**GENOA CHARTER TOWNSHIP
PLANNING COMMISSION
PUBLIC HEARING
AUGUST 9, 2021
6:30 P.M.
AGENDA**

Attention:	Kelly Van Marter, AICP Planning Director and Assistant Township Manager
Subject:	Highland Engineering – Sketch Plan Review #1
Location:	1125 and 1153 Grand Oaks Drive – east side of Grand Oaks, south of Grand River Avenue
Zoning:	IND Industrial District

Attention:	Kelly Van Marter, AICP Planning Director and Assistant Township Manager
Subject:	Tommy’s Express Car Wash – PUD Amendment and Site Plan Review #2
Location:	4591 E. Grand River Avenue – northeast corner of Grand River and Lawson Drive
Zoning:	NRPUD Non-Residential Planned Unit Development

**Re: Tommy's Express Carwash
Site Plan Review No. 2**

A200
7/16/2021
NOT TO SCALE

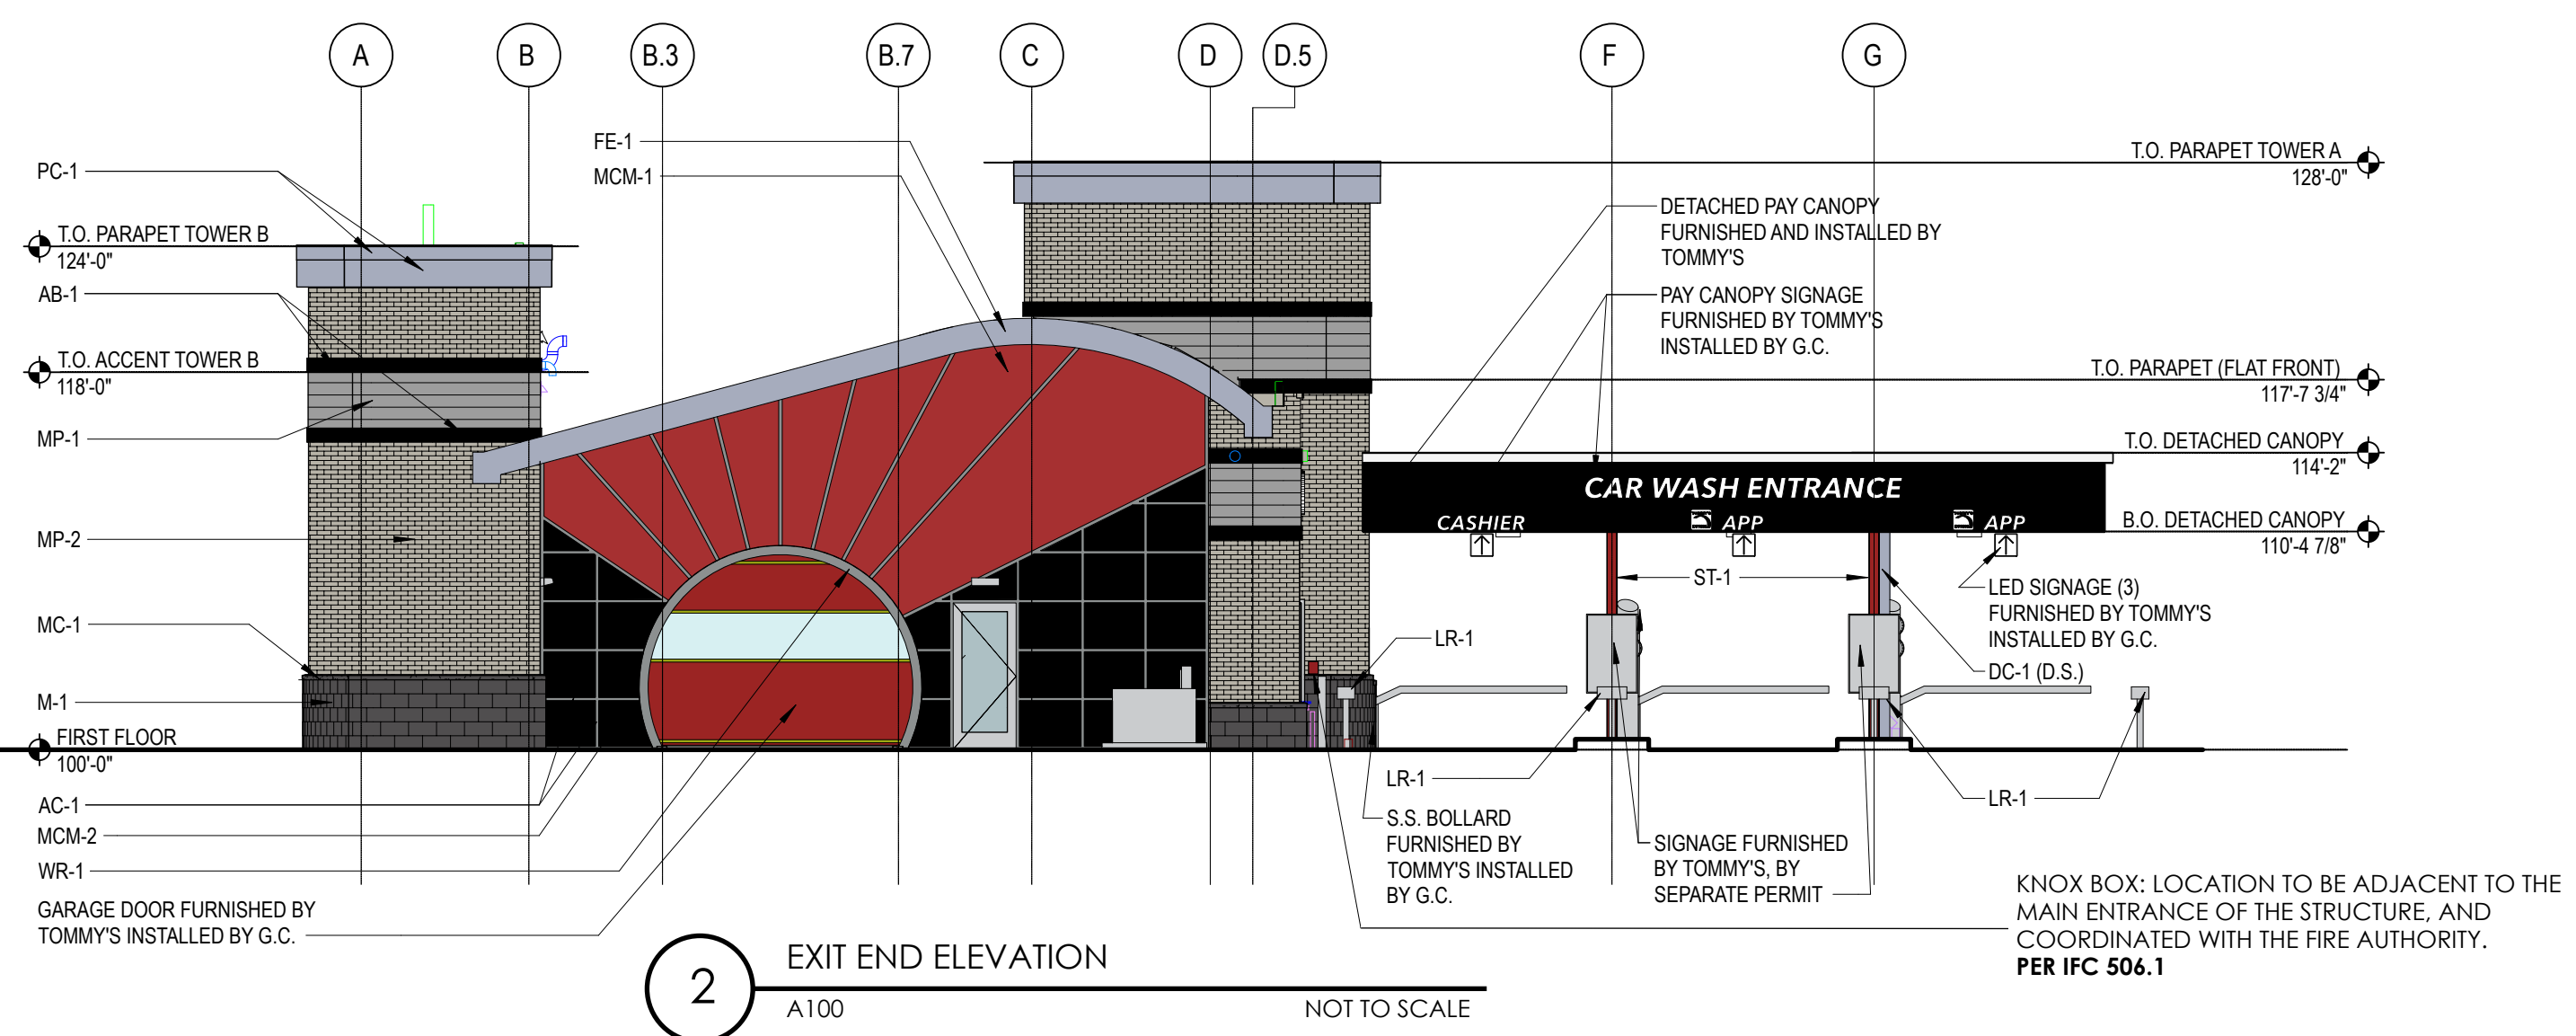
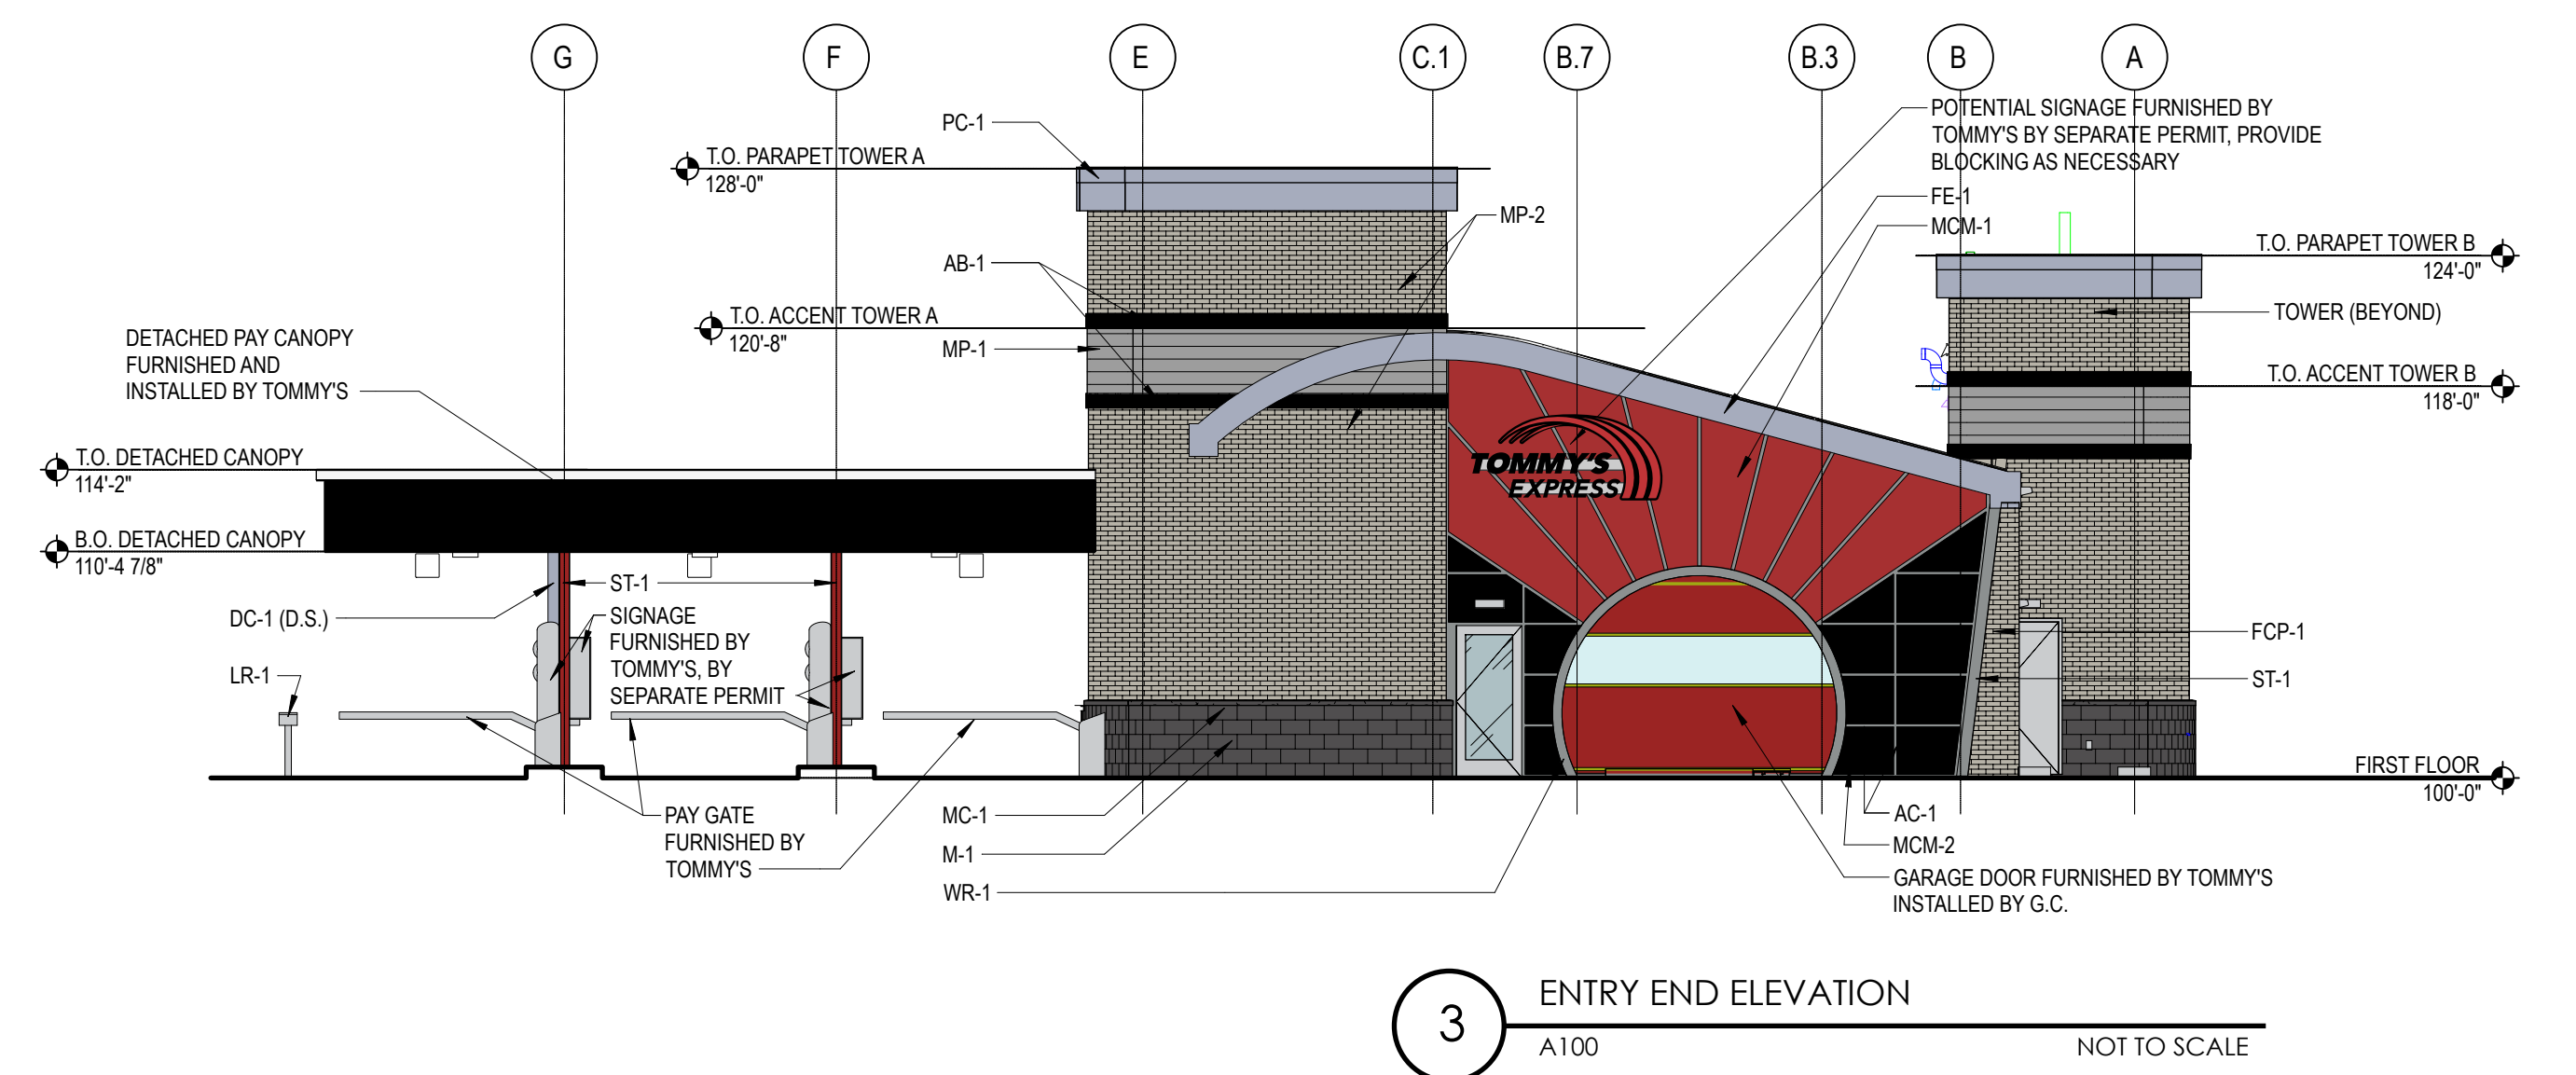
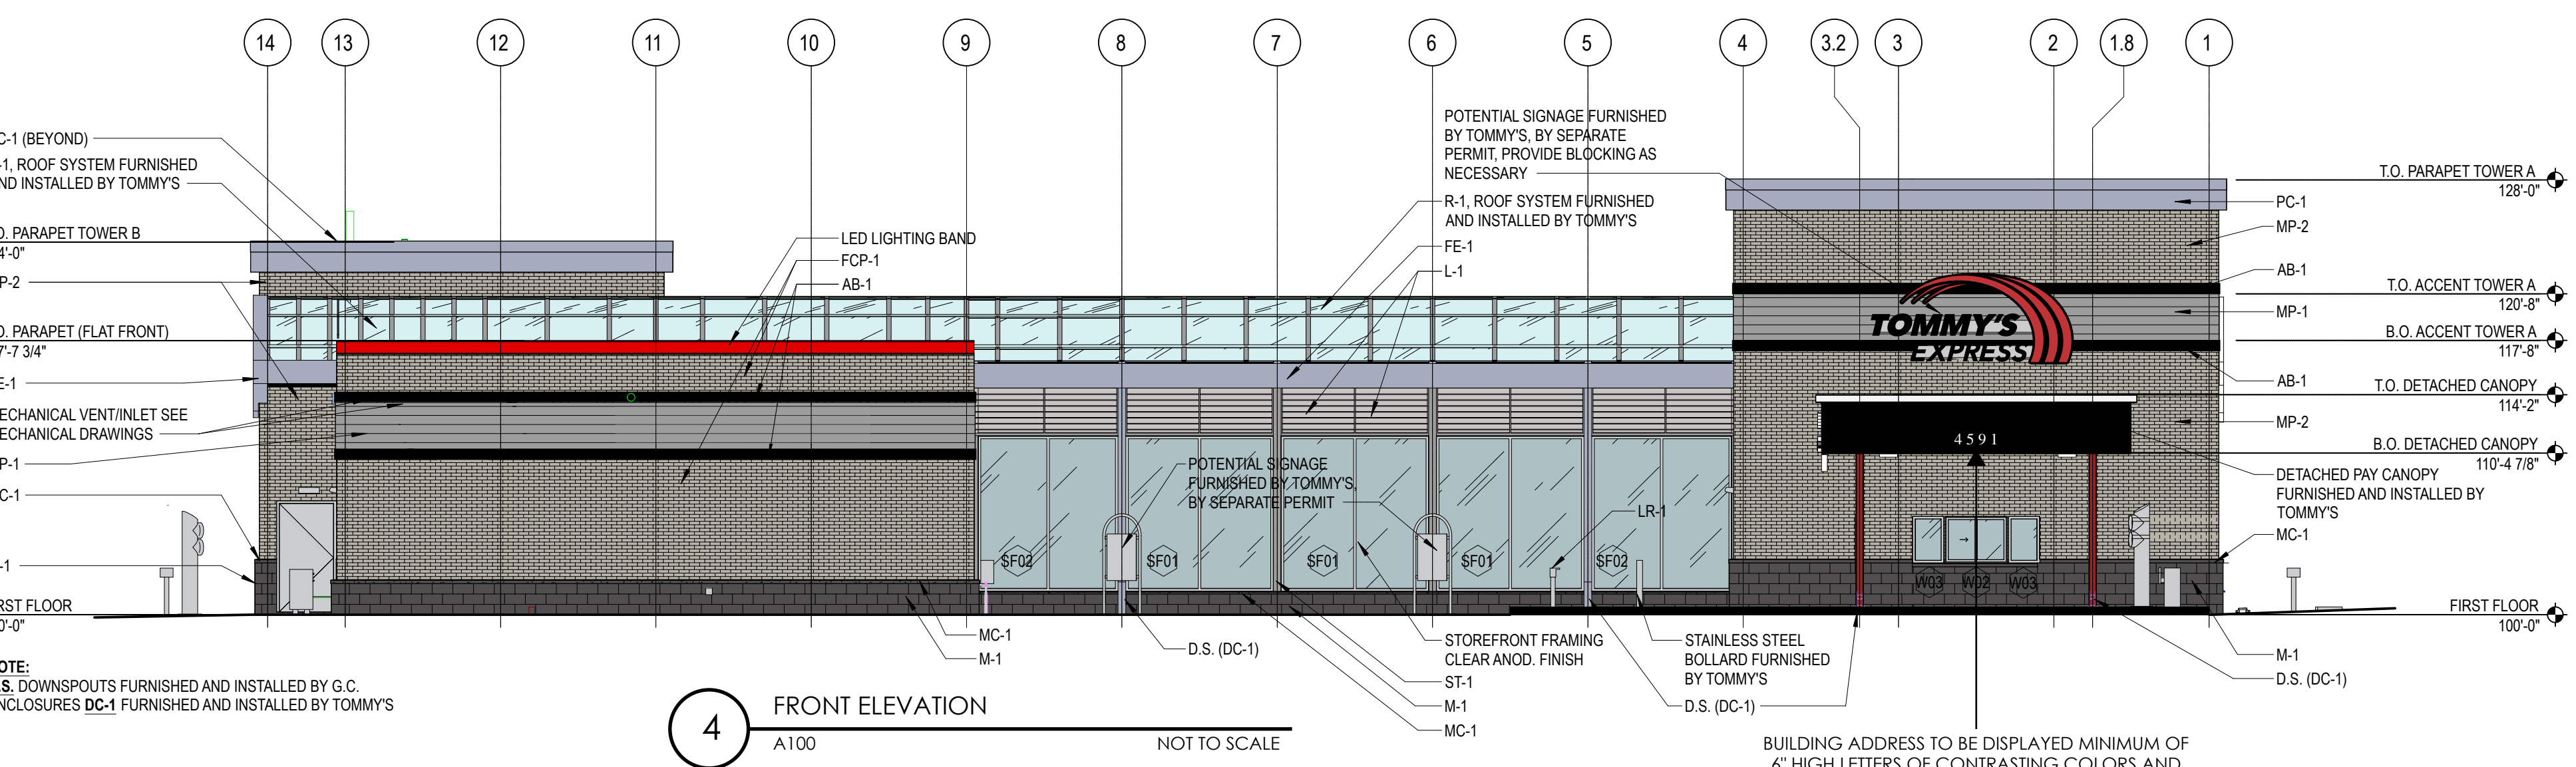
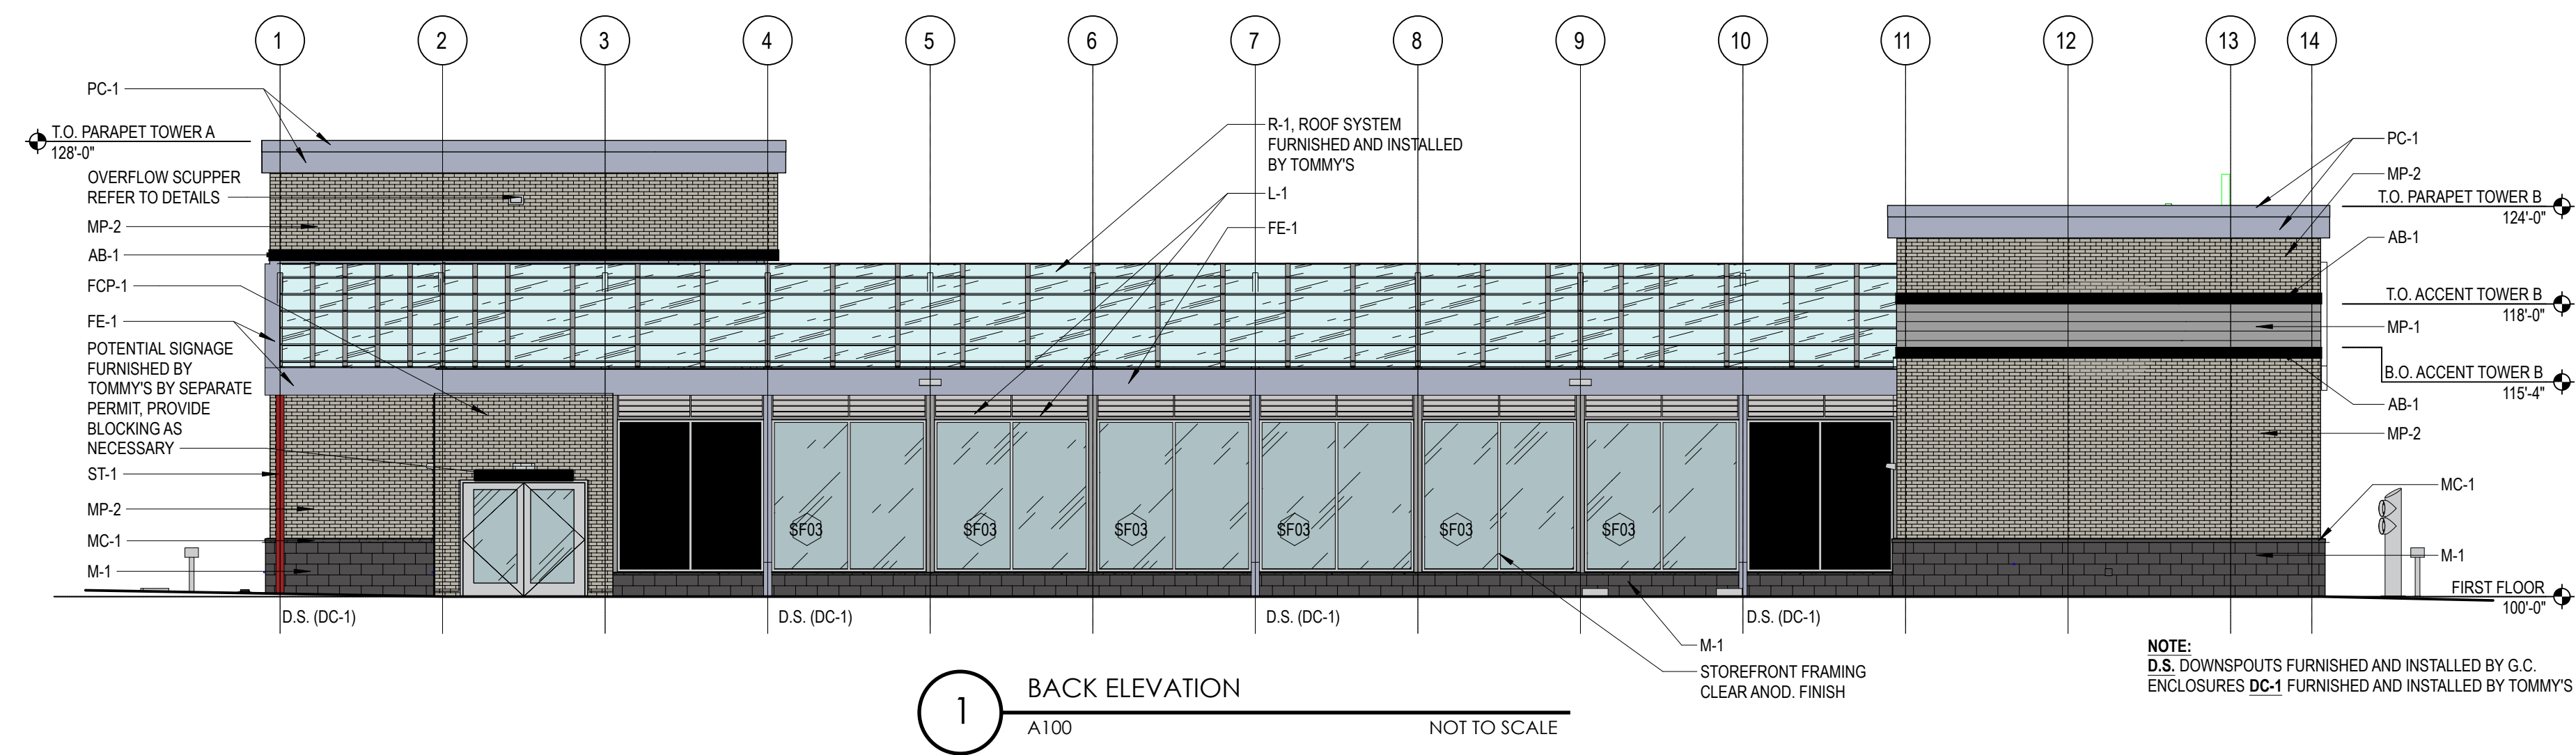
1. The building address shall be a displayed **minimum of 6"** high letters of contrasting colors and be clearly visible from the street. The location and size shall be verified prior to installation. **(Address numbers have been revised and shown on elevation SHeet A-200 to be compliant with the minimum requirements.)**

BUILDING ADDRESS TO BE DISPLAYED MINIMUM OF 6" HIGH LETTERS OF CONTRASTING COLORS AND TO BE CLEARLY VISIBLE FROM STREET. LOCATION AND SIZE TO BE VERIFIED PRIOR TO INSTALL. PER IFC 505.1
